**PLANNING AND DEVELOPMENT SERVICES STAFF REPORT**

**For Planning Commission Meeting of September 7, 2016**

**SUBJECT: Circle K Site Plan for City Council Approval  
(1420 East Stadium Boulevard)  
File No. SP15-014**

**SUBJECT: Circle K Site Plan for City Council Approval  
(1420 East Stadium Boulevard)  
File No. SP11-037**

SHEET NO.:  
C-3

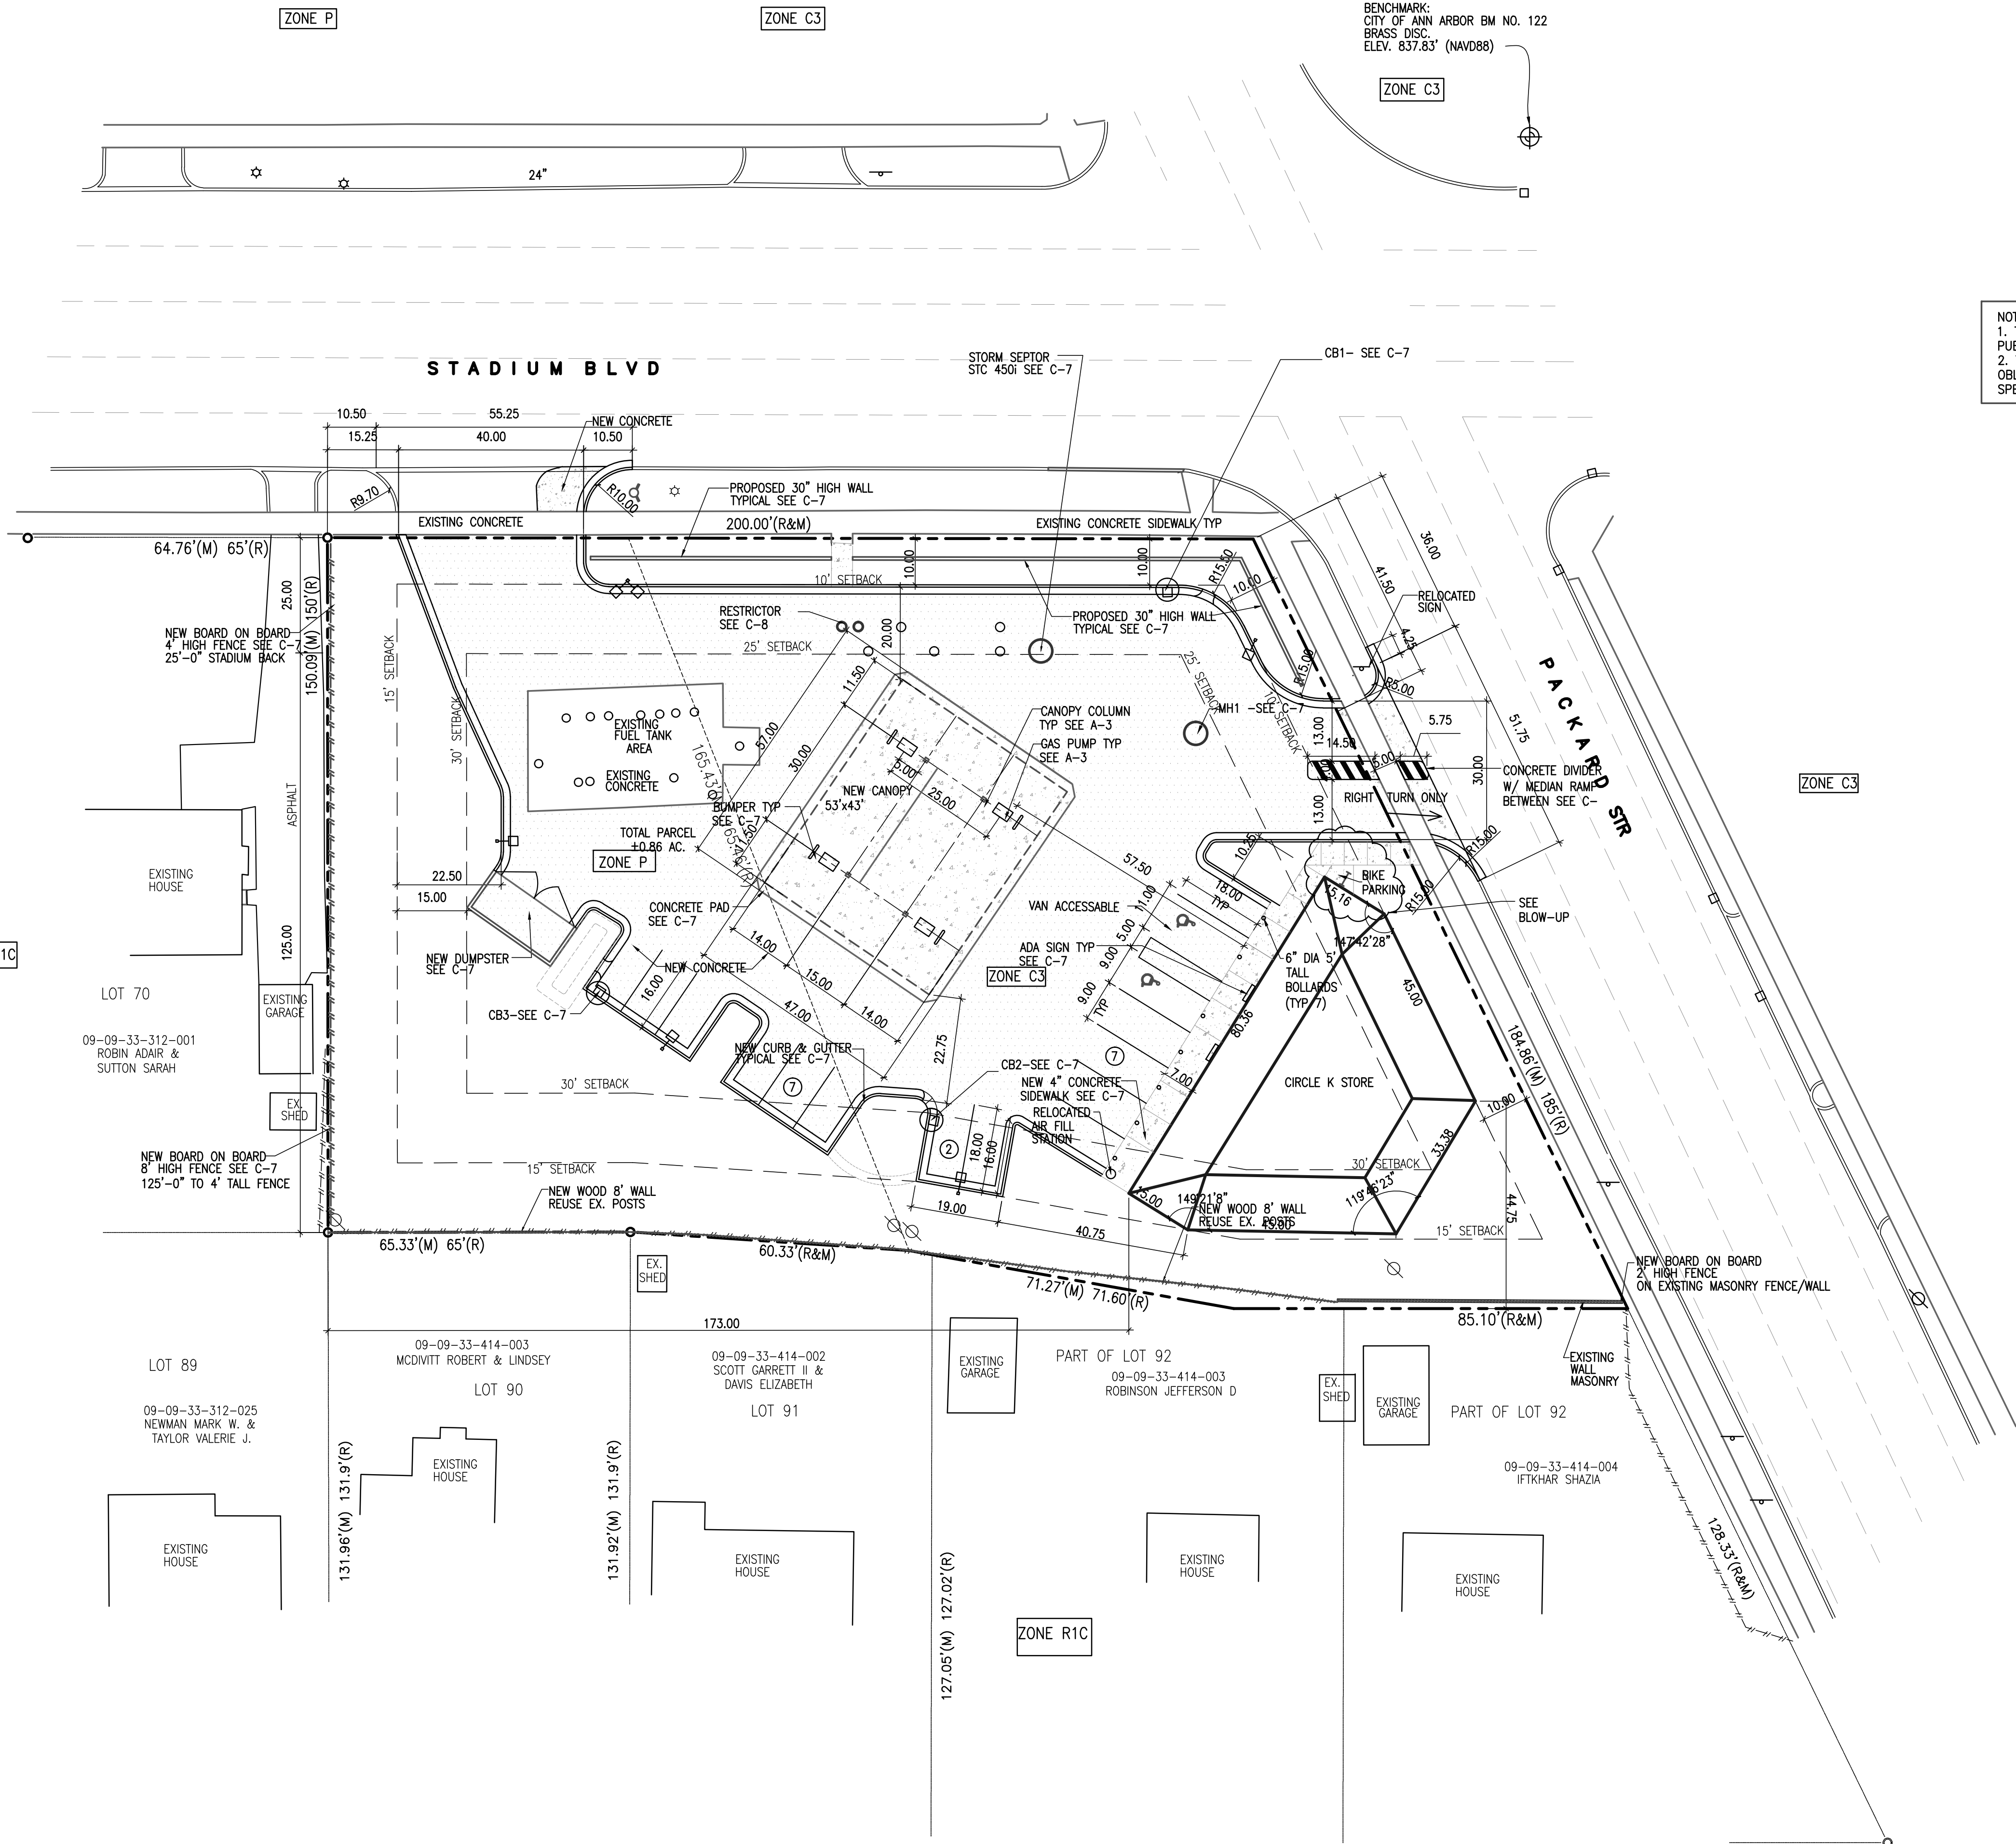
The site plan as proposed requires that two variances be granted from the Zoning Board of Appeals (ZBA). The first variance is for the driveway width to East Stadium. This drive is designed wider than the maximum required width in order to allow for solid waste and gasoline tanker trucks to enter the site safely and most efficiently. A variance for the rear setback is also required. Due to the unique constraints of the deed restriction for the western third of the site, vehicle circulation and the requirement for employees to have direct eye contact with the gas pumps, the petitioner feels the proposed location is the best to minimize impacts to the neighborhood and light pollution from the gas pump canopy.

Systems Planning (Engineering) – Sanitary mitigation calculations require revisions. The final mitigation amount required(if any) is pending, additional information is required.

Systems Planning (Soil Erosion and Stormwater) – Minor revisions are needed to the grading plan in order to ensure proposer drainage to the bioretention areas as well as proper overflow to the storm catch basins on the site.

Site lighting, in particular canopy lighting, was a major concern for the adjacent neighbors. In order to address this concern, the petitioner has constructed the canopy as far away from the adjacent residential as possible. They have also submitted an extensive photometric plan conducted by an outside consultant. The plan details lighting levels and fixtures that reduce light pollution well beyond the code requirement. The lighting plan uses fixtures and screening to reduce off site light trespass, these elements are part of the submitted site plan and must be constructed as shown on the plan.
